Electric Power Generation, Transmission, and Distribution; Electrical Protective Equipment; Corrections

ACTION: Correcting amendments.

SUMMARY: On April 11, 2014 (79 FR 20316), the Occupational Safety and Health Administration published a final rule: Revising the general industry standards for electric power generation, transmission, and distribution work and for electrical protective equipment; revising the construction standard for electric power transmission and distribution work; and adopting a new construction standard for electrical protective equipment. The final rule updated those standards and made the general industry and construction standards consistent. This document corrects errors in the preamble and regulatory text of the final rule.

Table R–3—AC Live-Line Work Minimum Approach Distance

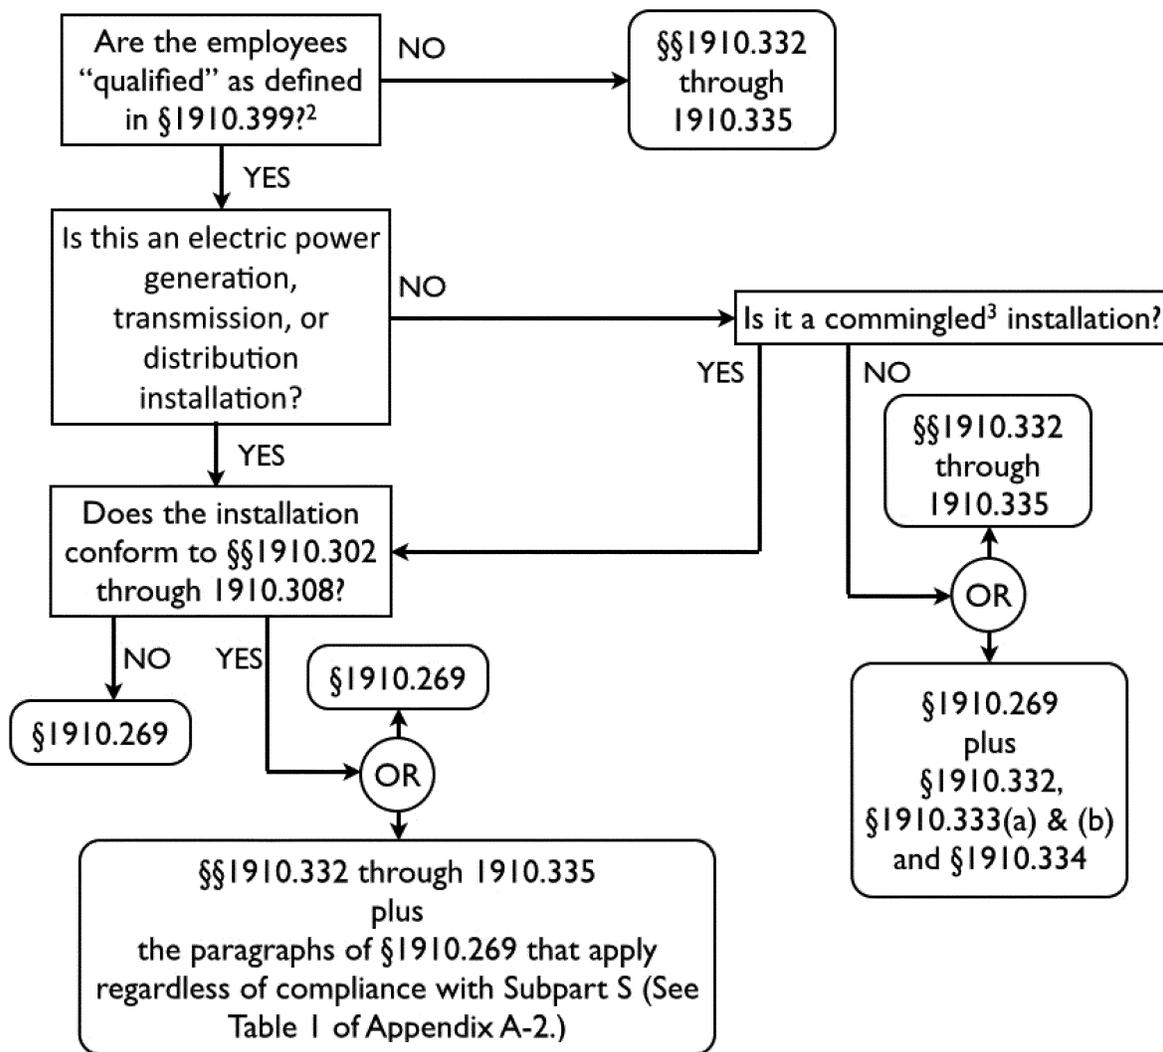
■ i. Under the entry “For phase-to-phase system voltages of more than 72.5 kV, nominal”, in the thirteenth row, revise the equation;

$$MAD = 0.3048(C + a)V_{L-GTA} + M$$
